PROJECT NAME: Birch Road Bridge Replacement

SOLICITATION NO: B201030

RE: ADDENDUM #1

SCALE: 1" = 20'	SHEET 1 OF 1
Job No.:	SHEET
Date: January, 2020	HORZ:
Drn By: WMR	VERT:
Ckd By: JFT	No. 73

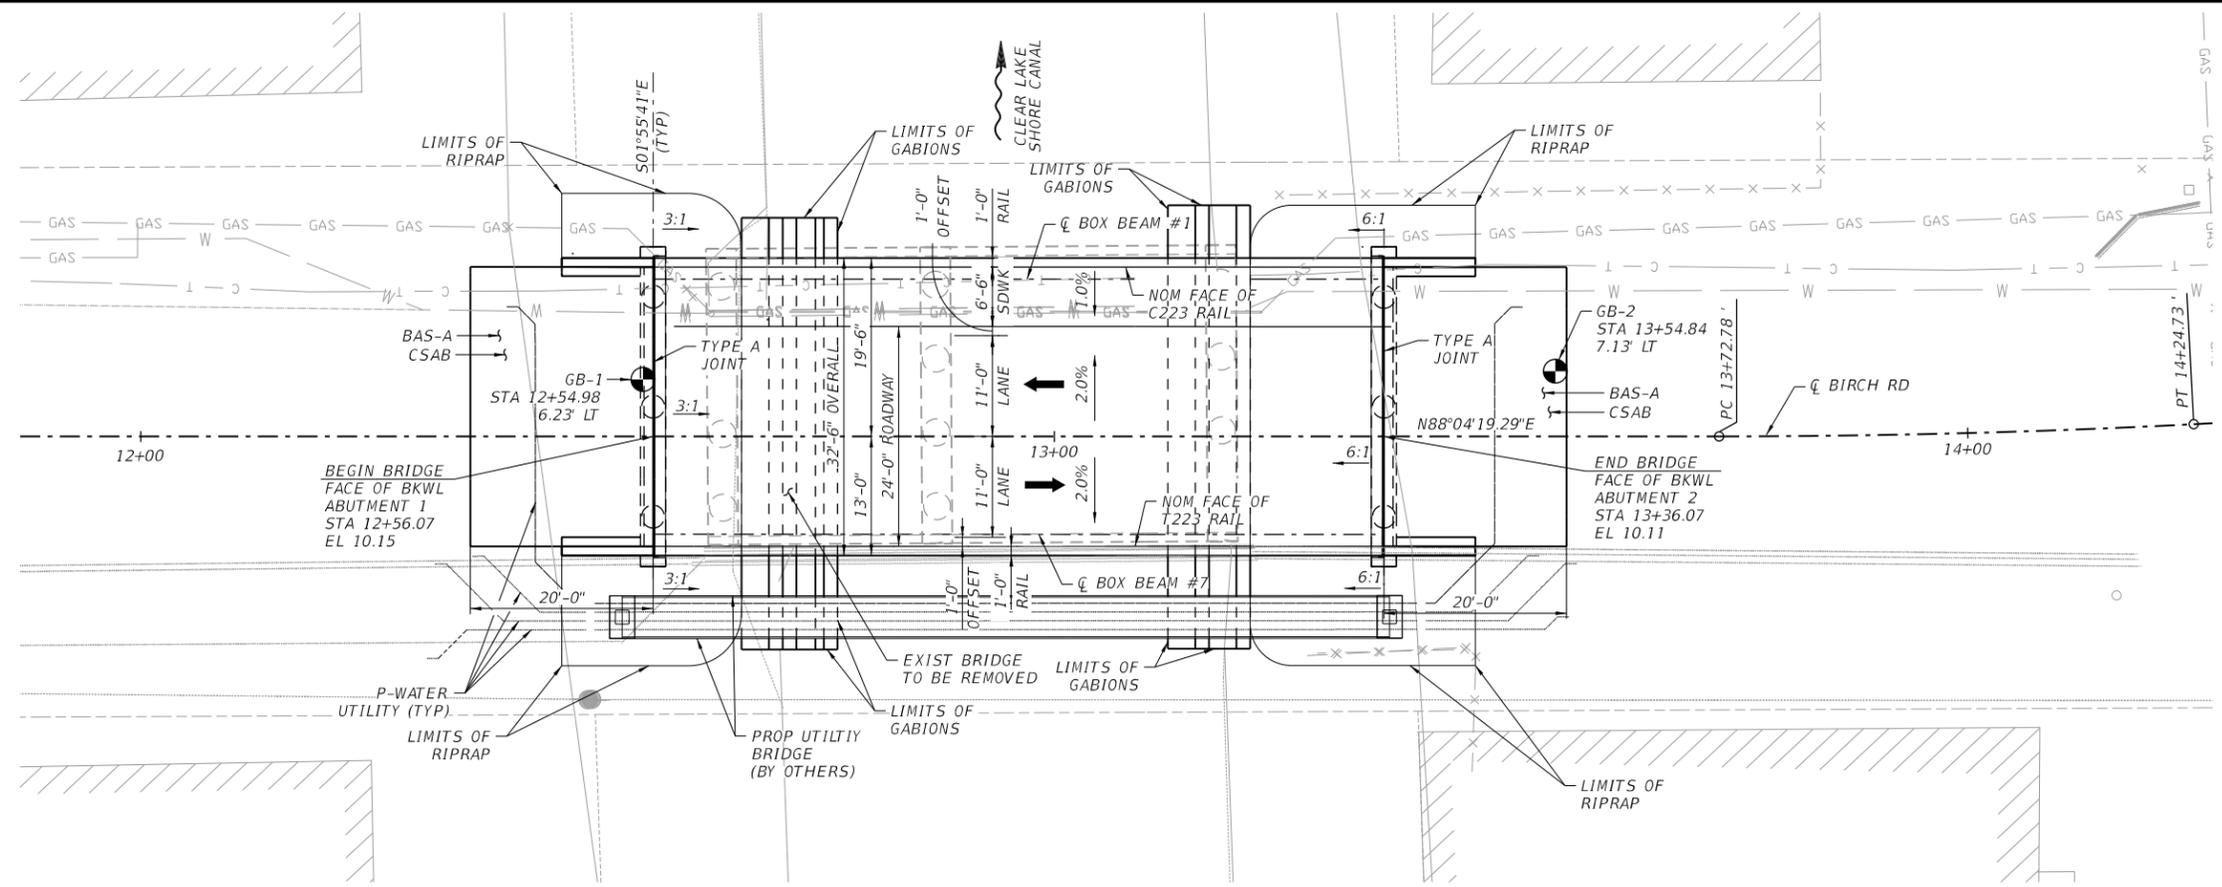
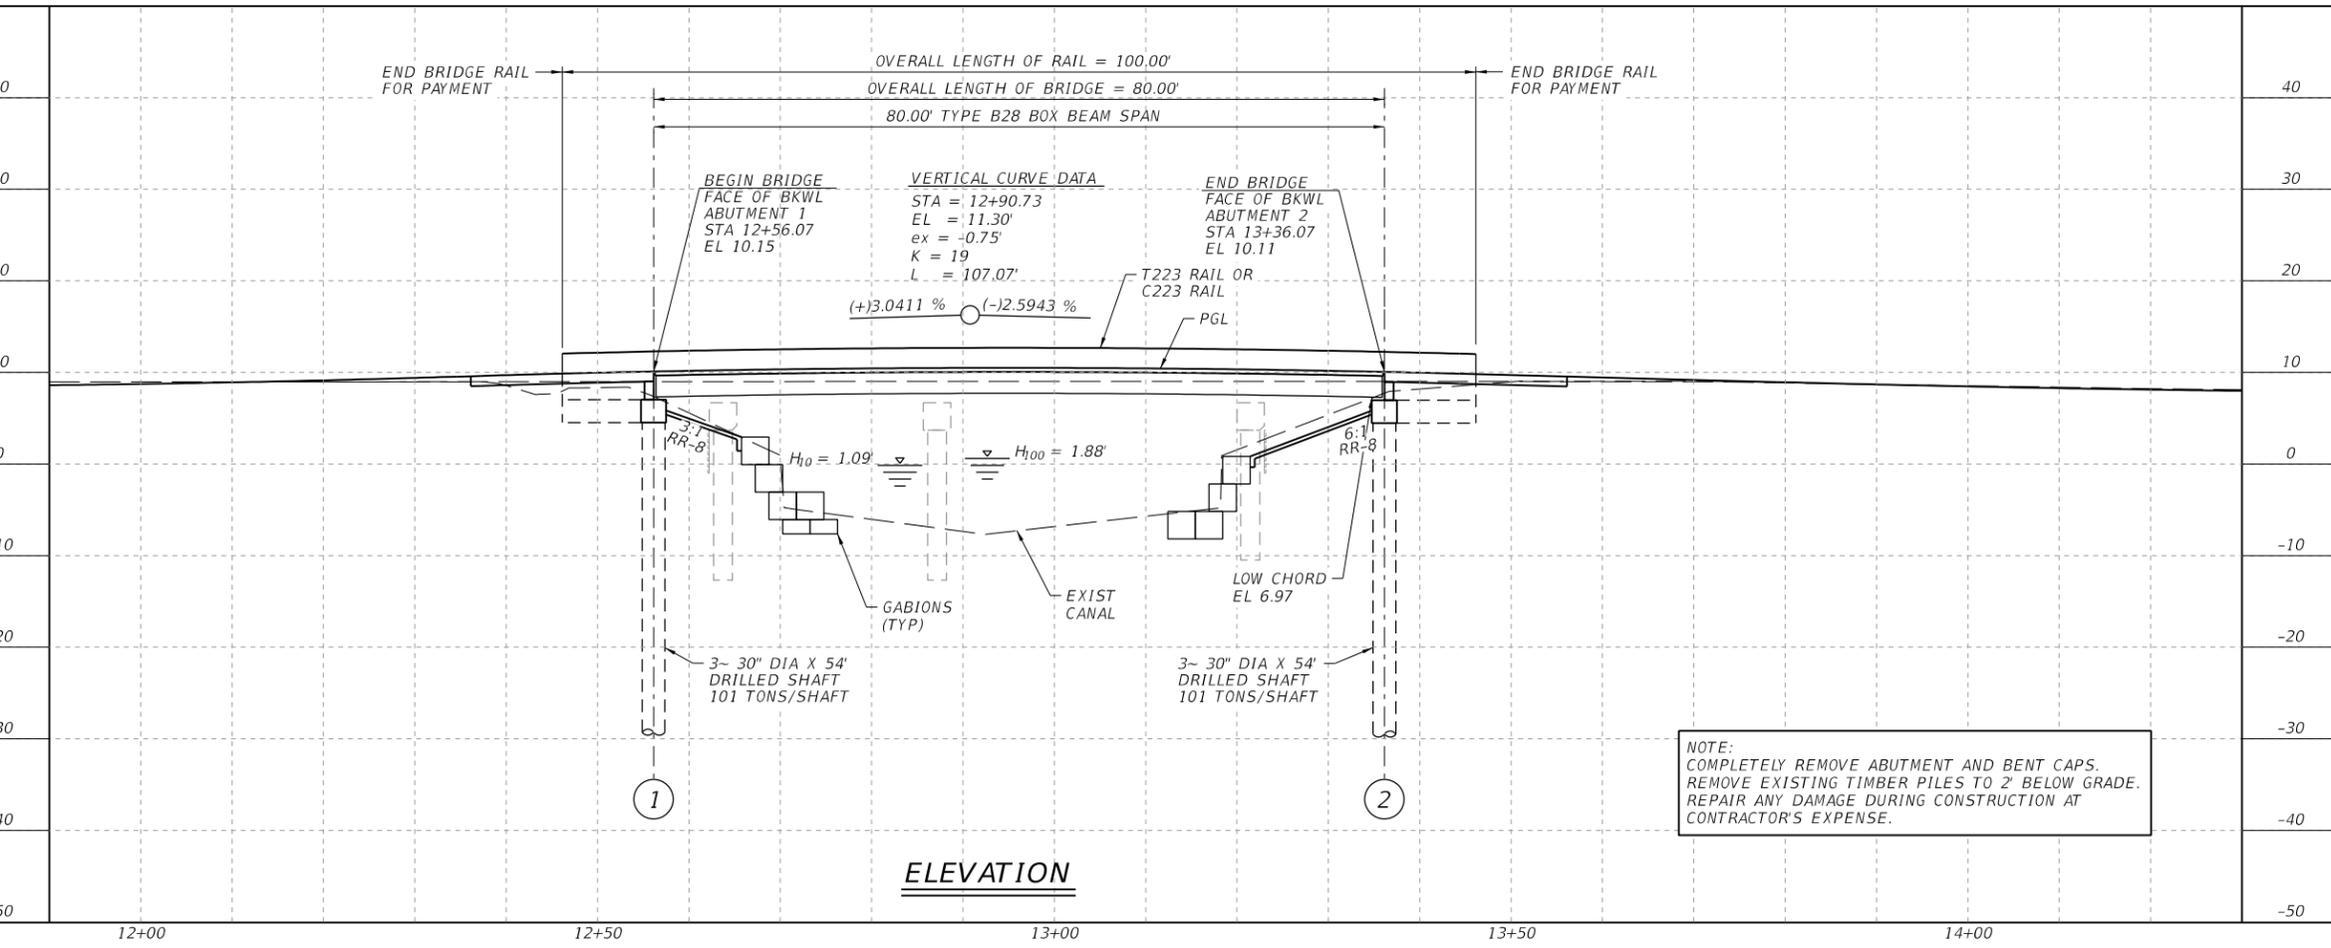
Question #2: *If support columns do exist. Please clarify at what height will support columns be cut-off?*

Question #6: *What size is the existing railing?*

Response: The existing bridge has interior bents with timber piles. See Sheet 73 for note regarding where the piles should be cut.

Response: Not sure the size of the existing railing is relevant. The whole existing bridge is going to be removed. For rail types on the new bridge, see Sheets 73, 74 and 80.
